**SERVICE
BULLETIN**

MANDATORY SERVICE BULLETIN Z 242L/19a - Rev.3, Z 143L/20a
Supersedes Mandatory Service Bulletin Z 242L/19a - Rev.2

1. **DATE:** April 30, 1999
2. **MODELS AFFECTED:**

Fig. 1

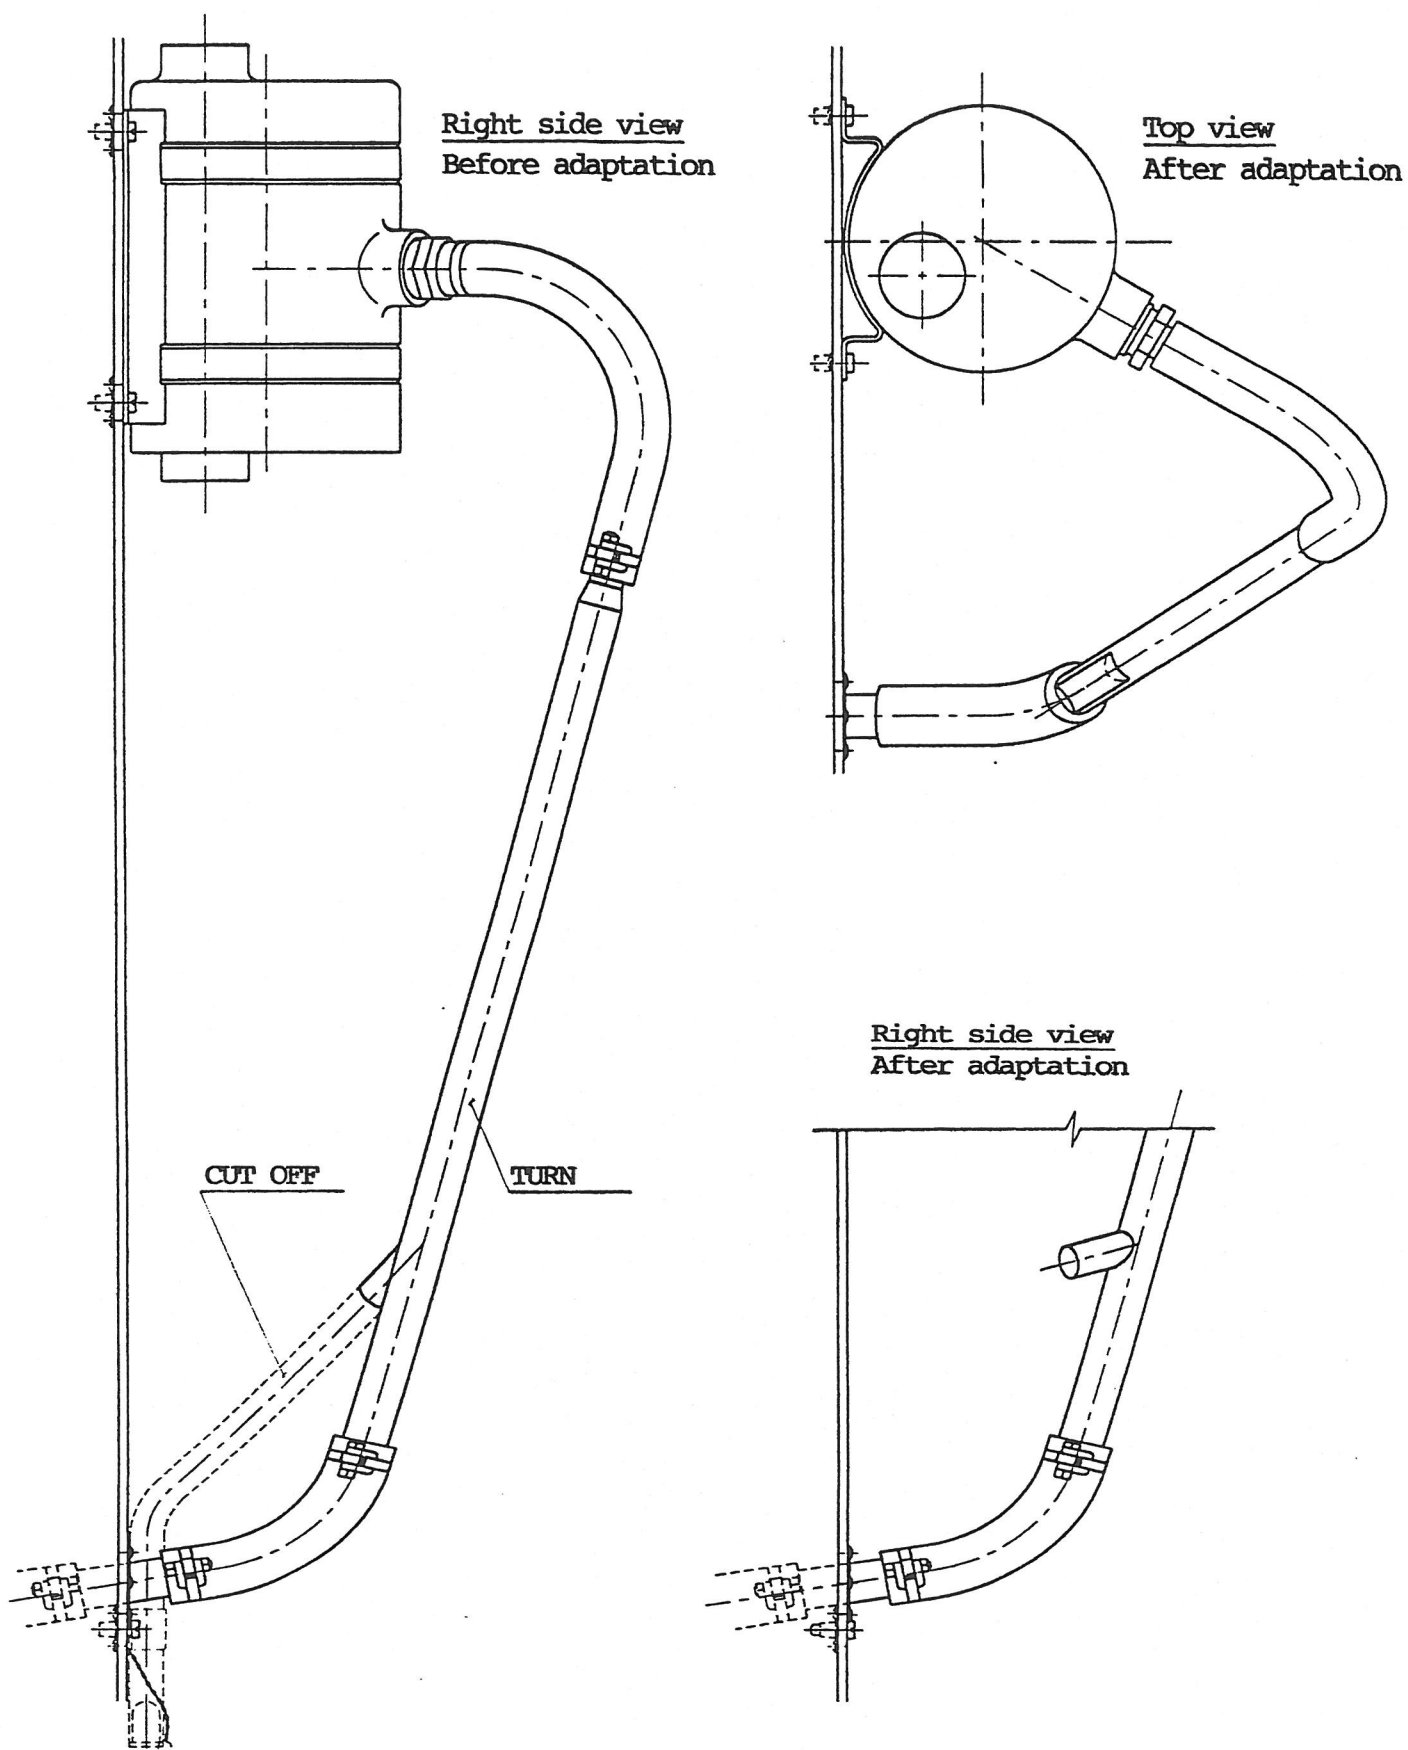
Remove oil residues from the dismantled tube and cut off the secondary line (thinner) at a distance of 20 - 30 mm from the tube of the main vent line (see Fig. 1)

Slide the tube back into the hoses and turn it in such a way that the remainder of the secondary line will be aimed obliquely to the back (slightly to the right in order that the reminder is in alignment with the main vent line tube from the top view - see Fig. 1).

Fig. 2

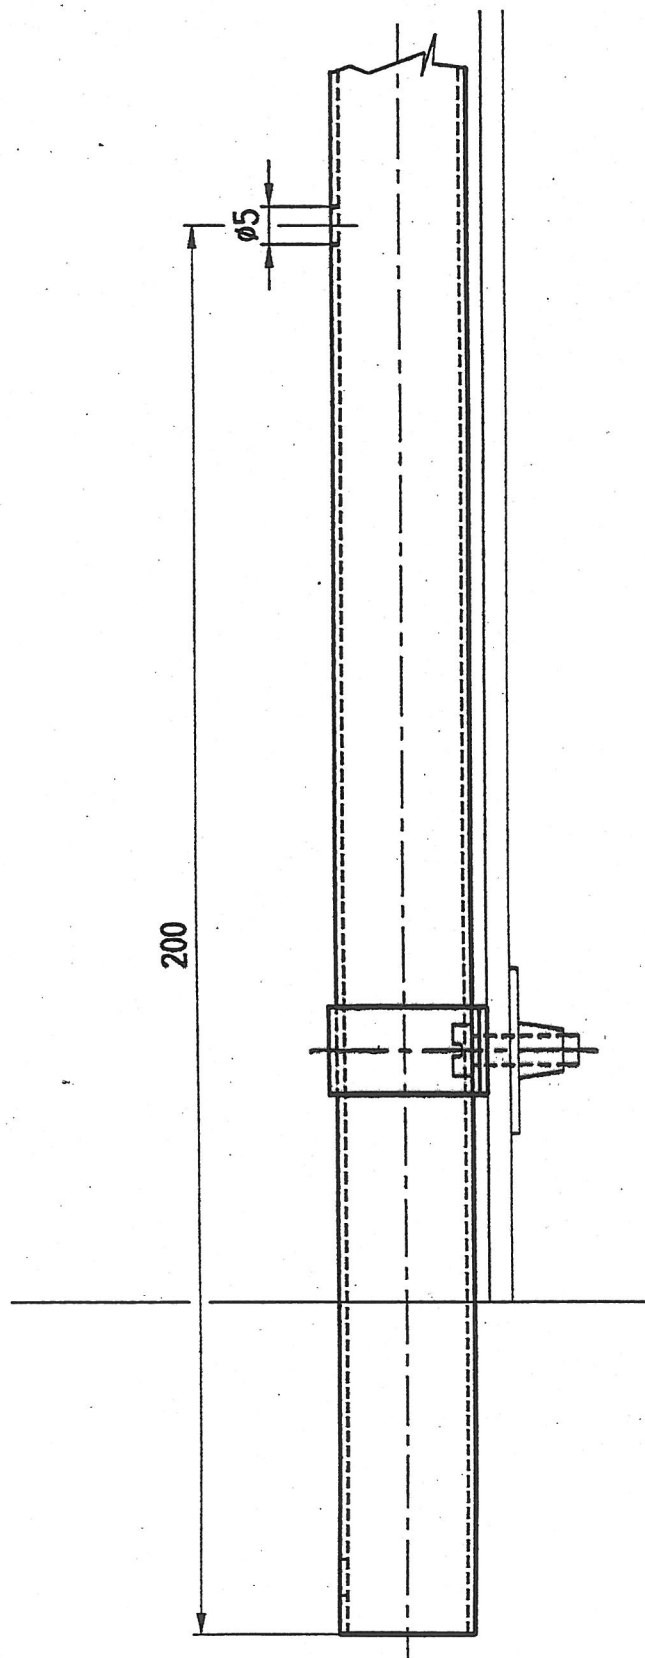
Dismantle the vent tube, drill the hole in accordance with Fig. 2, install the tube back - position of the hole in accordance with Fig. 2.
